1.0 SOLAR ACCESS OF SSDA – PITT STREET SOUTH OSD (PSS OSD)

This document is in response to requests for information. The document demonstrates the changes that have happened to solar access for not only the PSS OSD site, but also its resultant impacts on the Princeton Apartments. It will summarise and update the following documents which have been issued over time:

Image 1 – View From Sun at 10am showing units of Princeton Apartments that would have been overshadowed by SSDA Application.

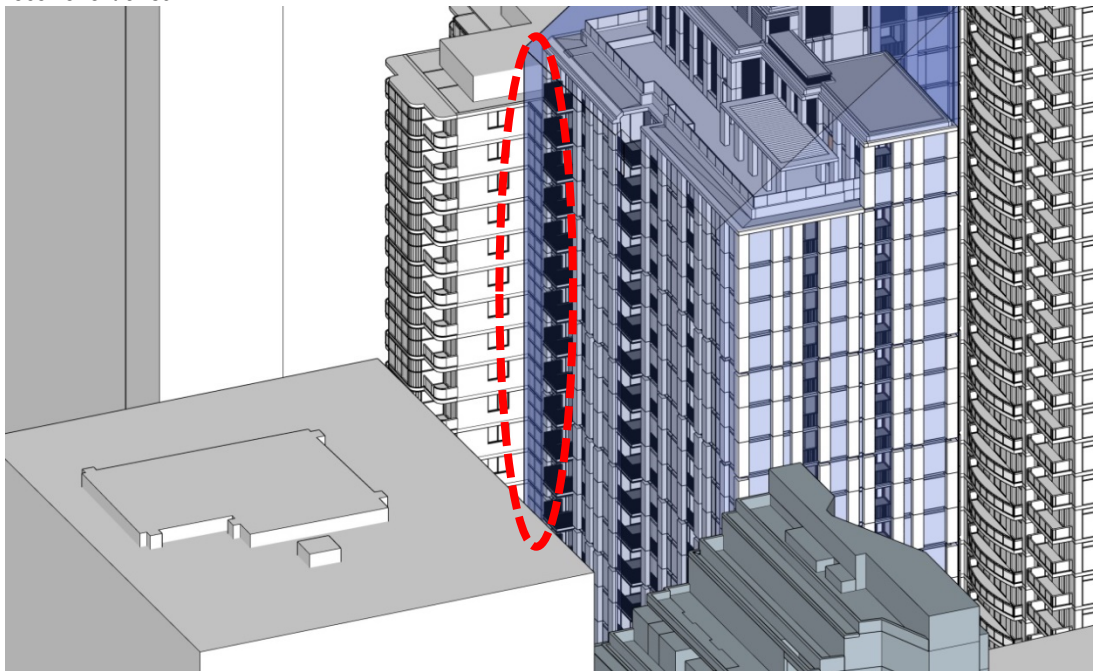
We have also been asked to demonstrate where the main gains of solar access have been across the current SSDA verse the Approved Concept Envelope. Firstly we need to establish the difference between minutes gained verse the quantum of sun gained. At some times which are noted below, a unit may have complying solar access, but due to changing the balcony width, the amount of sun received by that unit may increase from 1m^2 to say 4m^2 . For our calculations, anything over 1m^2 is counted as complying solar access, but a unit may now receive significantly more sun; therefore improving the amenity afforded to these units.

The Current SSDA has an increased setback to the East of the site. The SSDA building has been set back to allow an increased amount of sun to Princeton Apartments. The below image is taken at 10am and it shows the Approved Concept Envelope in blue, with the current SSDA and Princeton Apartments in a solid white. The Princeton Apartments that you can see in the blue area of the image below all would have been overshadowed at this time under the Approved Concept Envelope; but by setting the building back, these apartments all receive extra sun.

Image 3 – Showing increased quantum of sun due to reduced balcony widths.

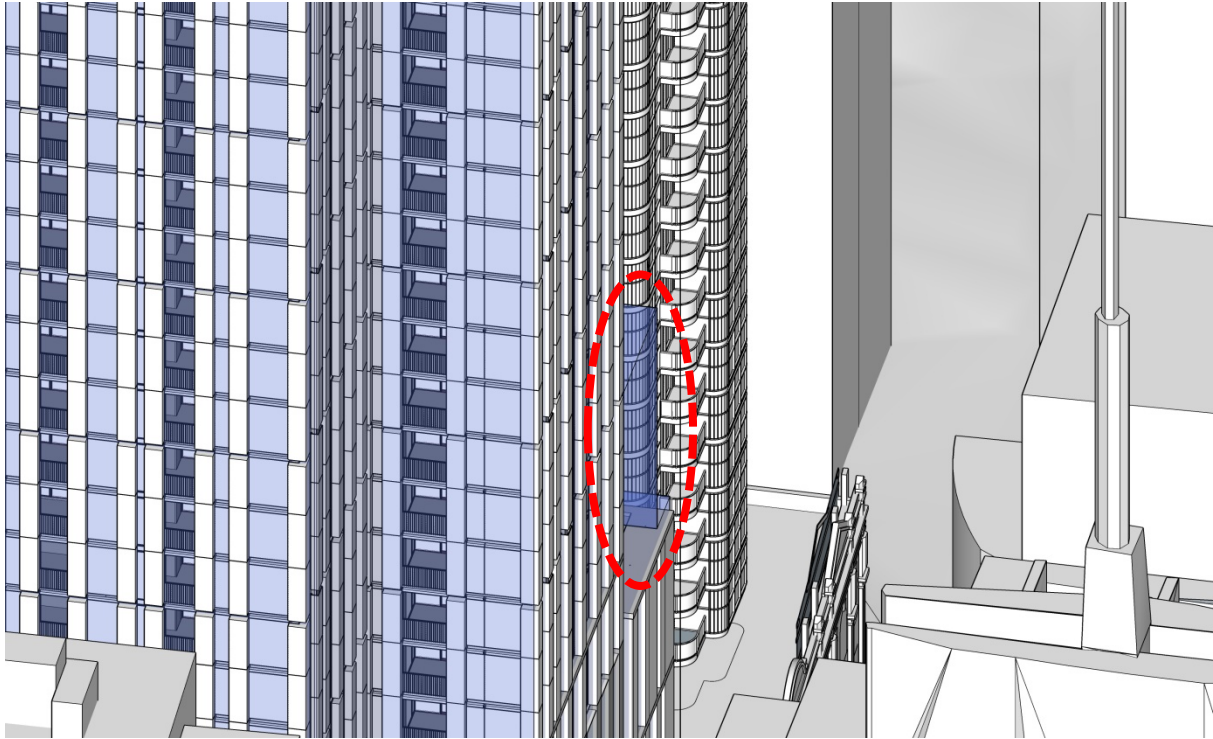
Not only has the setback improved the amount of minutes a unit may receive, but changes to the model between the Original SSDA and the Current SSDA have led to increased amenity to these Princeton Apartments. In the below image you will see where the balconies used to be full width, they used to cover much more of the glazing of these Princeton Apartments. Whilst we have noted there has been no change to the Solar Access due to the change of these balconies, we need to make clear that this is only talking from a strict compliance perspective. We count solar access from 1m^2 , which is still received by these Princeton Apartment in the Original SSDA. Now that the balconies have reduced in width, we now have an increased quantum of sun to each apartment. This increased quantum of sun leads to a better amenity outcome to each unit.
